BULLETIN # 202B

MC91-0, 92-0 & 93-0, MC100-0,101-0 & 102-0

OUTPUT RECTIFIER REPLACEMENT

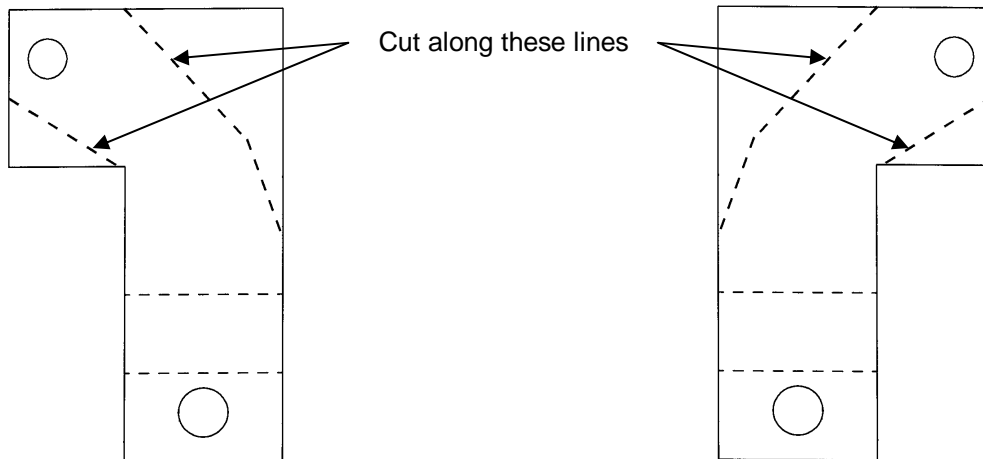
A new batch of output rectifier modules (part number D0017) have been causing the toroids on the output busbars to overheat during load bank testing. This is due to a change in the operating characteristic, and while the rectifiers still perform within their specification, this overheating problem now exists when we use them in our machines.

To prevent the toroids from overheating, we are now using 2 toroids per busbar on new machines.

It will be necessary to add an extra toroid to each busbar when replacing the output rectifier module during service repair work (whether on MC10X series or MC9X series). The busbars will need to require modification to allow room for the extra toroid to be fitted.

Use a sharp pair of snips or shears to modify the busbars which connect the transformer to the input terminals of the rectifier module to the following shape:

Order 2 more toroids, P/No L0006 and fit them on the modified busbars, making a total of 2 toroids per busbar.
